6C Containment Debris Protection for ECCS Strainers

The information in this appendix of the reference ABWR DCD is subject to several changes due to the adoption of a complex ECCS strainer design (e.g. Cassette Type Strainer). Consequently, for clarity it is presented in its entirety with the following departures incorporated. This strainer design has been used at numerous BWRs in Japan and numerous PWRs in the United States. The strainer is described in this appendix. Departure STD DEP Vendor changes General Electric (GE) to Toshiba in Section 6C.1.

STD DEP 6C-1 (Figure 6C-1)

Figure 6C-1 Cassette Strainer Cutaway

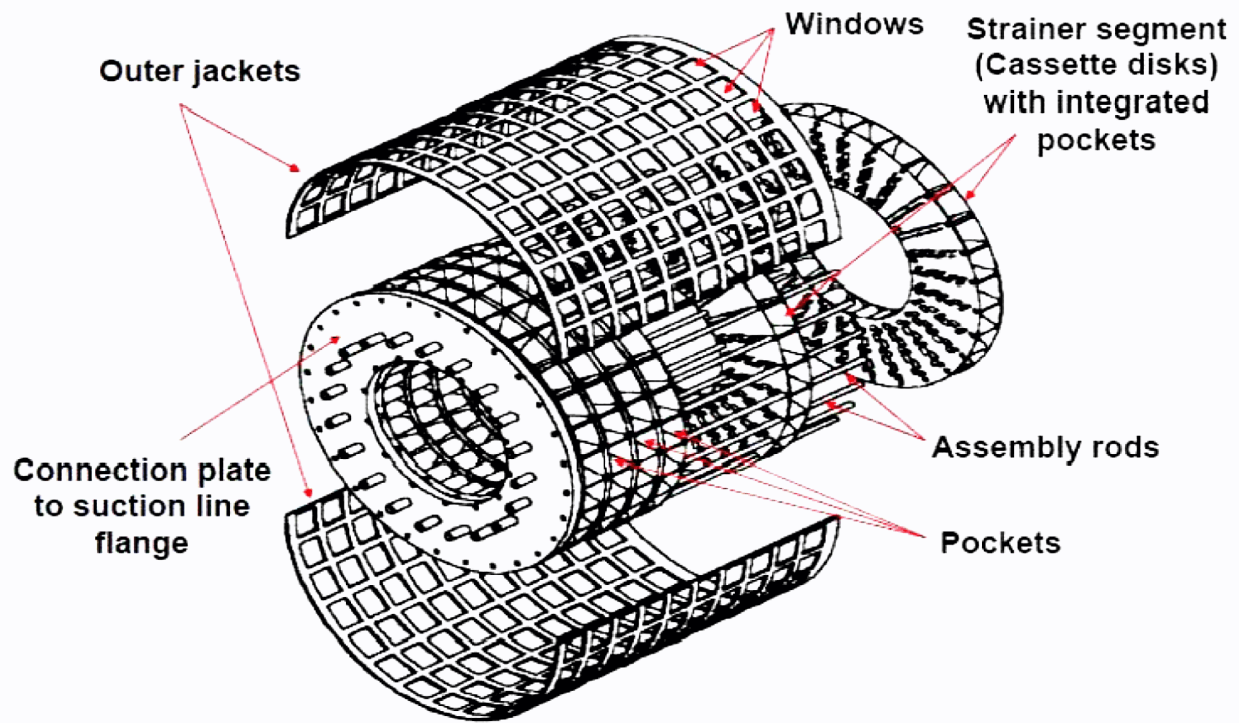
The suction strainers design at Perry preceded and did not meet the current regulatory requirements. The ABWR ECCS suction strainers will utilize a “T” arrangement with conical strainers on the 2 free legs of the “T” a cassette type strainer design. This design separates the strainers so that it minimizes the potential for a contiguous mass to block the flow to an ECCS pump. The design of the strainers will be based on Regulatory Guide 1.82, NUREG/CR-6224 (Reference 6C-4), NUREG/CR-6808 (Reference 6C-5) and the Utility Resolution Guidance, NEDO-32686-A. The cassette type strainer design is based on a set of cassette modules with U-shaped filter pockets attached to the cylindrical outer jacket. Each strainer consists of filter modules, the outer jacket and flange plates on each end of the cylindrical assembly. The filter module is constructed with cassettes which are arranged axially along the strainer axis. One cassette consists of pocket shaped filters which are arranged radially. A cut-away drawing of the strainer is shown in Figure 6C-1. The material used in the cassette type strainer is stainless steel. The cylindrical strainer assemblies are mounted in pairs on piping tees at each ECCS pump suction line. When the ECCS pump operates, the suction flow in the suppression pool runs into all pockets through the outer jacket windows. Each pocket has five flow paths from the inlet through the five perforated walls to the outlet of the pocket towards the cassette strainer. By using the cassettes with the pocket shaped filters, the strainer has an available filter area which is larger per volume than cylindrical and other shaped strainers. The number of cassettes and pockets is adjusted to produce a specific head loss performance for the strainer. To avoid debris clogging the flow restrictions downstream of the strainers, the size of the holes in the perforated sheets is chosen by considering specific flow paths of ECCS equipment and piping (for example, the containment spray nozzle and the ECCS pump seal cooling flow orifices). The strainers will have holes no larger than 2.1 mm.

- (6) ~~(5)~~ *The equipment installed in the drywell and wetwell minimize the potential for generation of debris.*
- (7) ~~The ECCS suction strainers~~ *The cassette-type ECCS strainers meet the current regulatory requirements unlike the strainers at the incident plants.*
